PP71/2019-1

29 Surf Avenue SKENES CREEK

Construction of a Double Storey dwelling

Response to your RFI letter dated 30 April 2019 as follows;

TITLE: **DESIGN RESPONSE
SITE PLAN**
 © Copyright
PLANNING APPROVAL

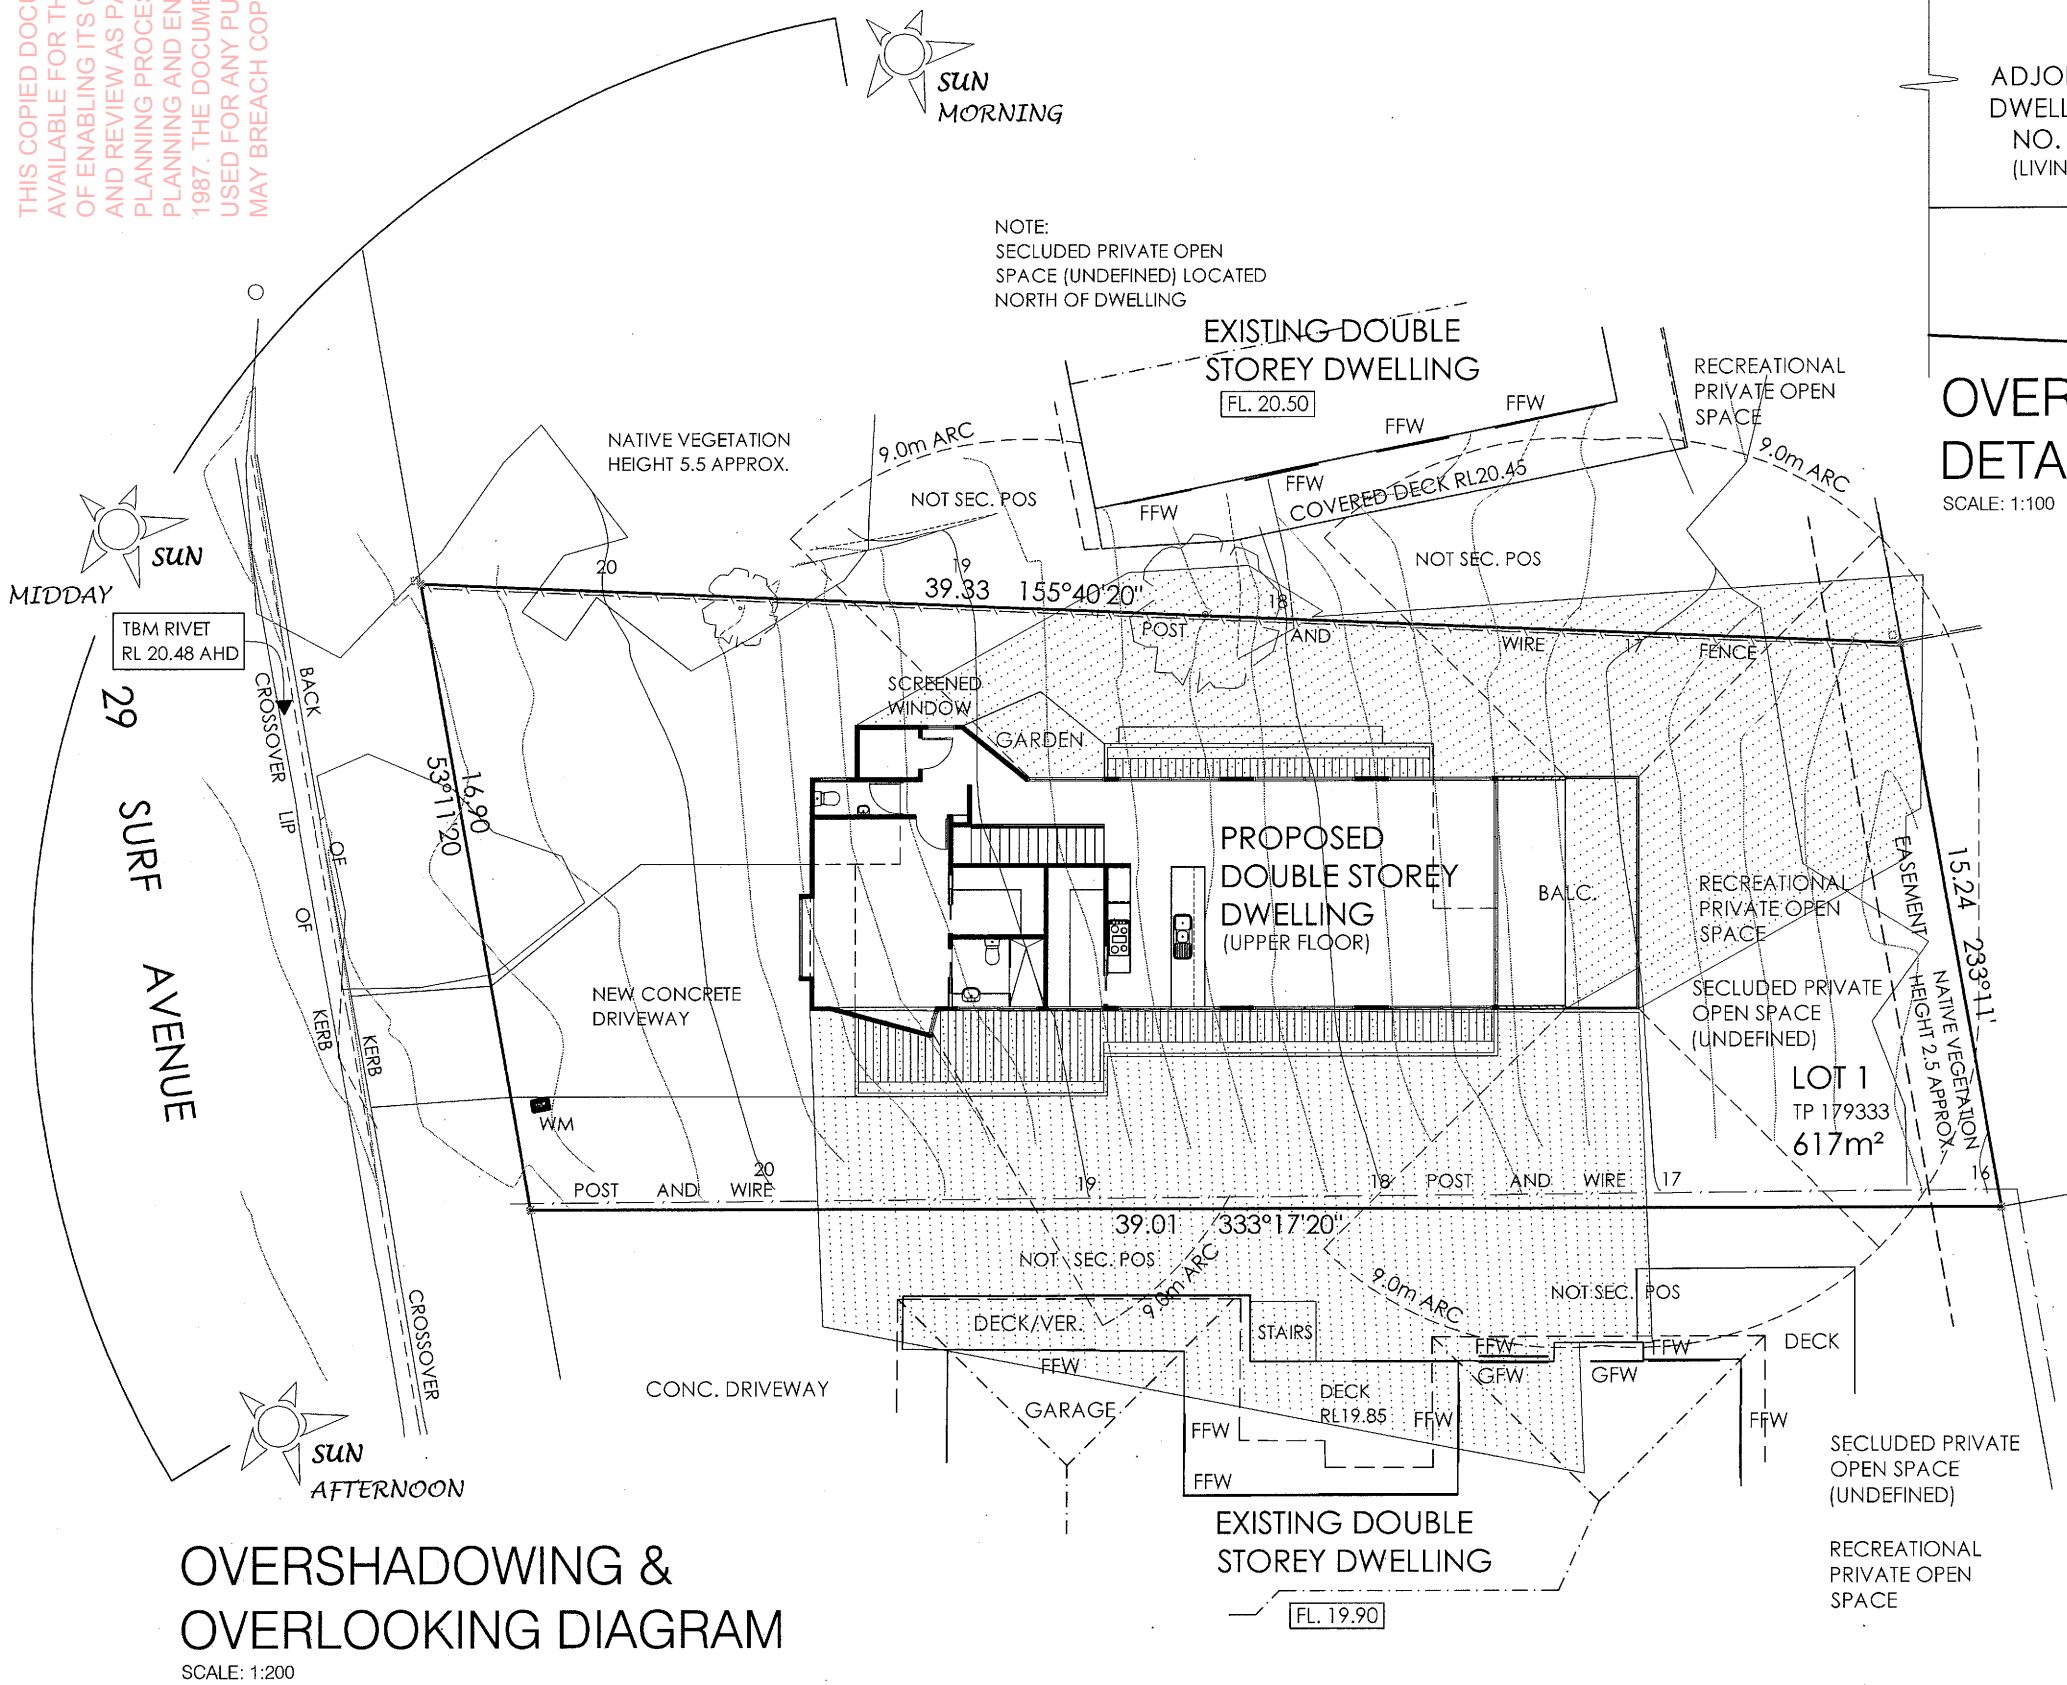
2. 1.7m high fence - The screen fence has been removed from the proposed works and the area of secluded private open space has been relocated to the rear of the site, refer to amended Design Response Site Plan.

6. Standard A17 & A18 - The area allocated to secluded private has been relocated to the rear of the property in conjunction with the area of recreational private open space, refer to attached amended Design Response Site Plan.
7. Proposed driveway - The proposed driveway has been altered to reduce the crossover width to 3.0m wide, refer to amended Design Response Site Plan.

TITLE: **OVERSHADOWING & OVERLOOKING DIAGRAM**
 © Copyright
PLANNING APPROVAL

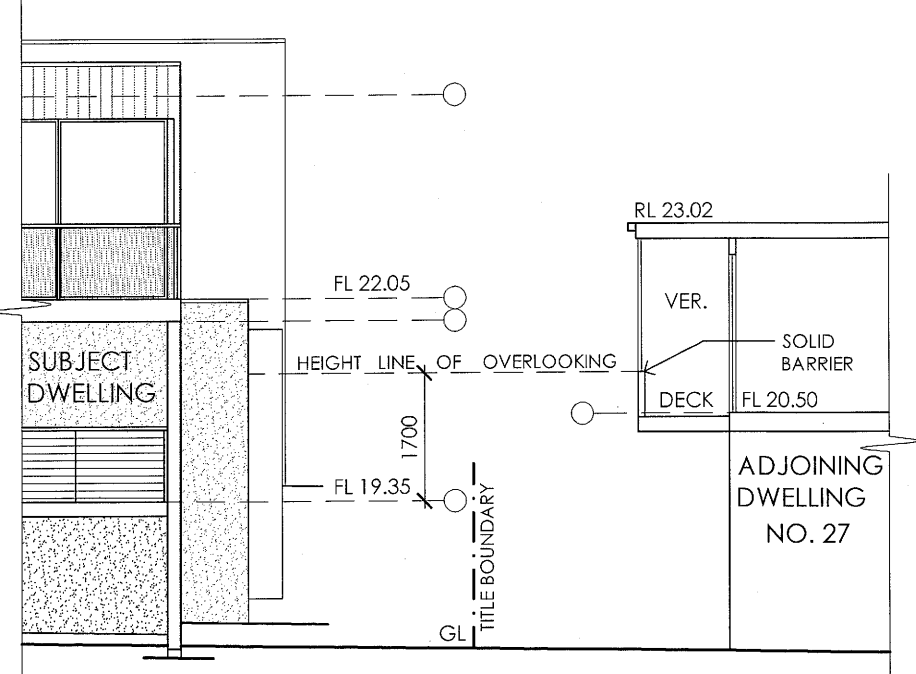
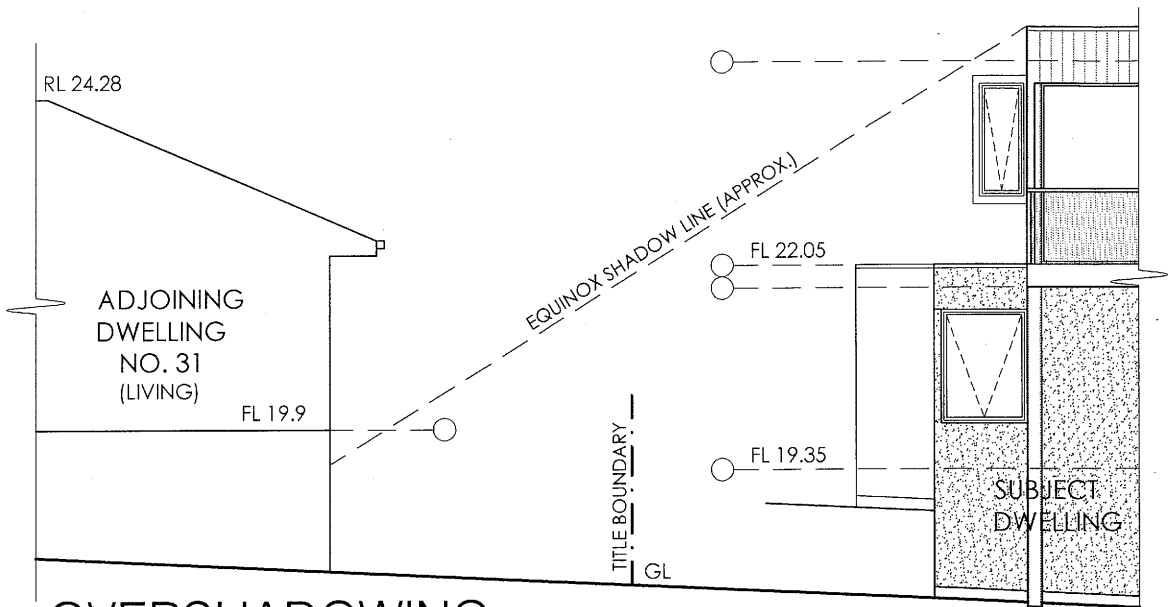
The overlooking detail shown on sheet 3 of 7 is to indicate that the solid balustrade prevents overlooking to the existing habitable room windows of 27 Surf Avenue from the proposed lower floor habitable room windows.

Restrictive covenant - It's considered that the proposed overlooking mitigation and justification response is appropriate, it is also considered that 1700mm high visual screens to the sides of the balcony would not constitute it being 'closed'.

DATE: **28/05/2019**
 SHEET No. **7 OF 7** REV. **A**
 SCALE: **1:100 @ A3**
 JOB No. **19-023**

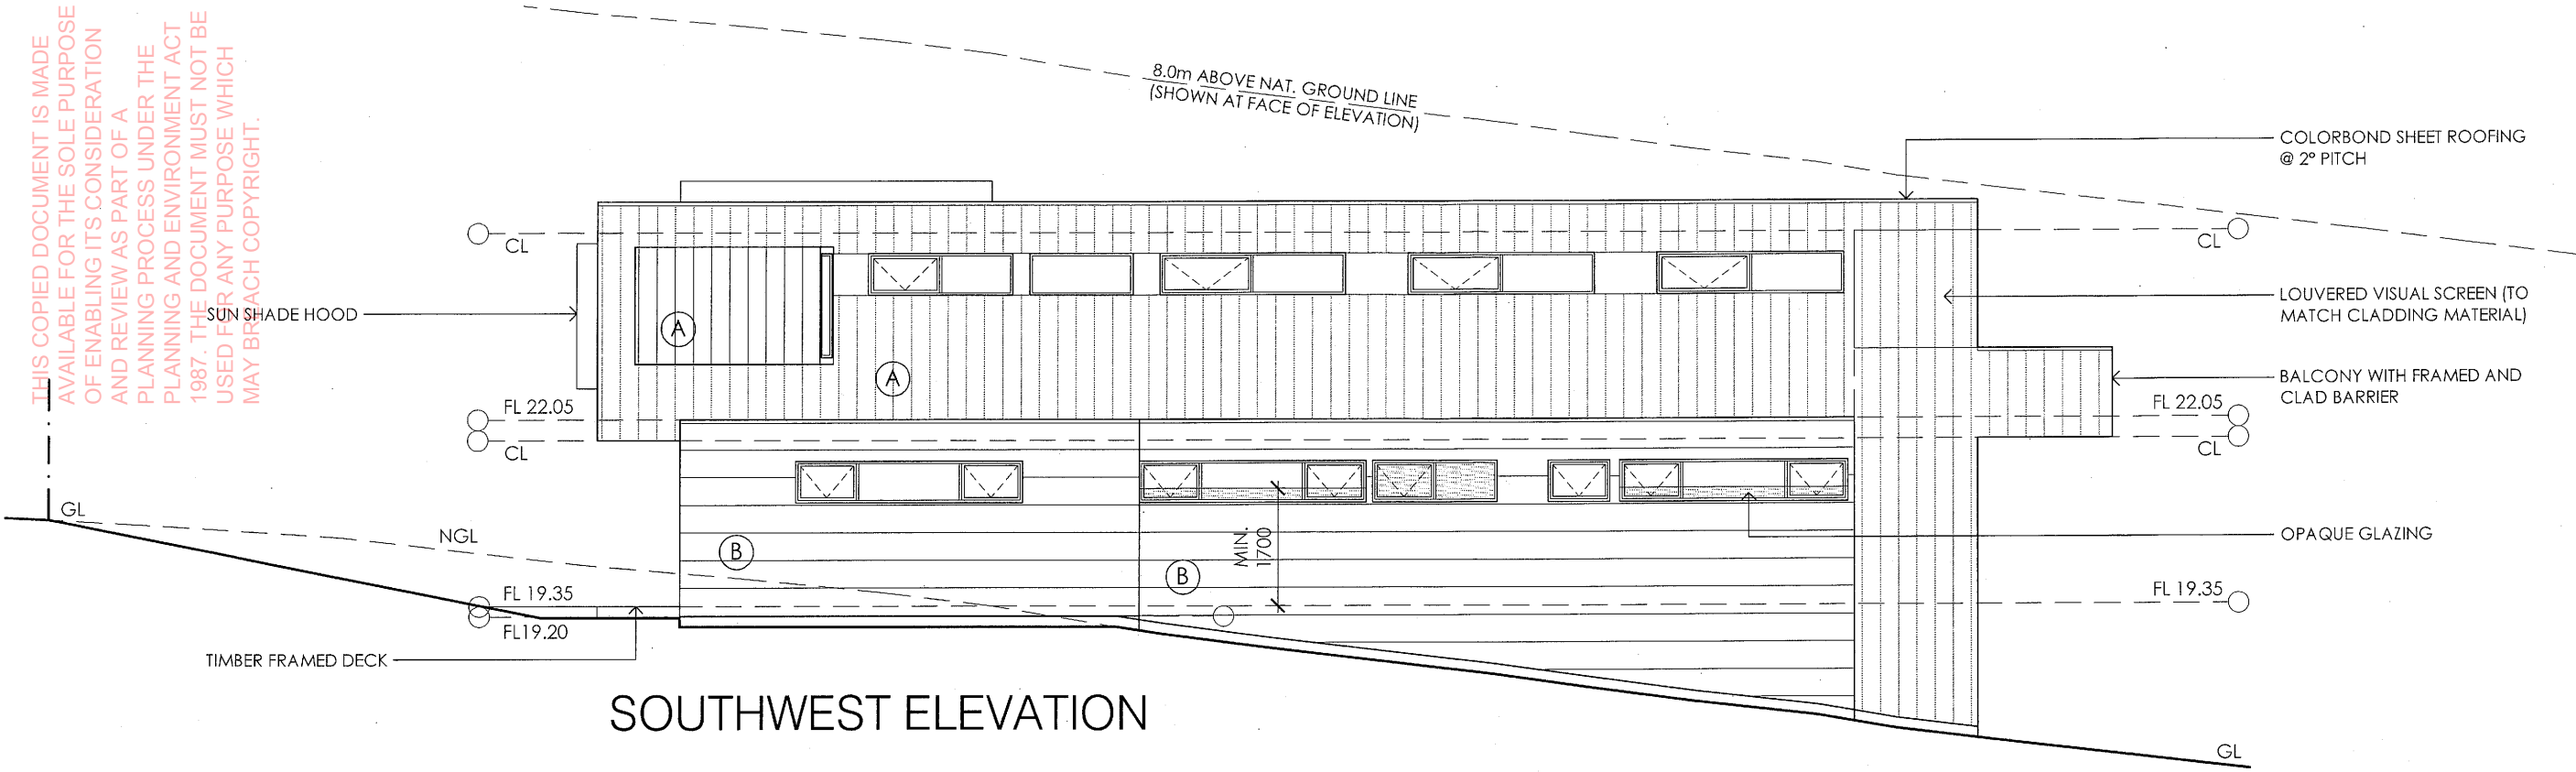
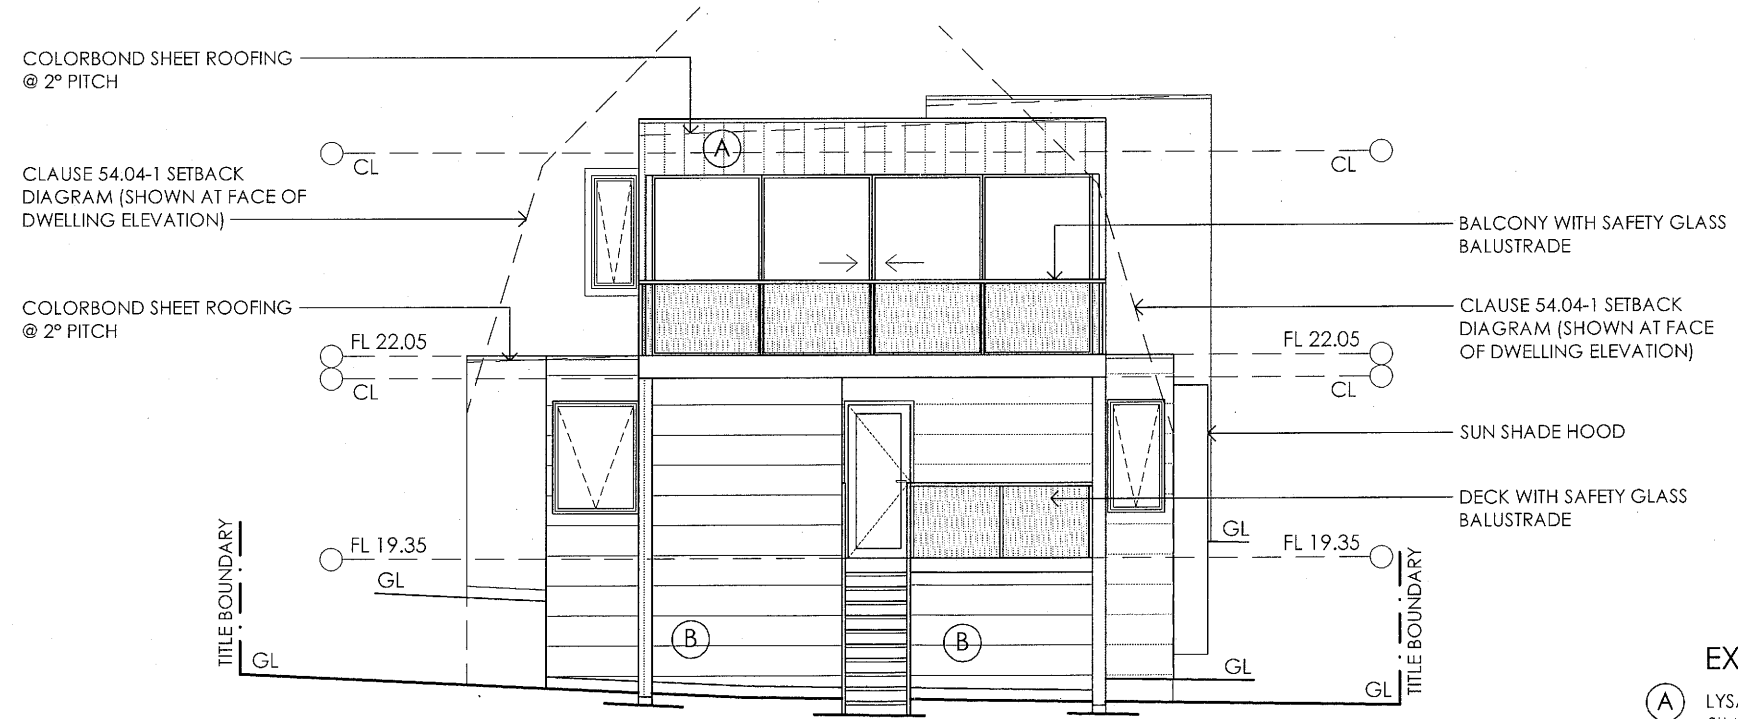
The habitable room windows of the lower floor were intended to be opaque to a height of 1.7m, refer to attached amended elevations drawing.
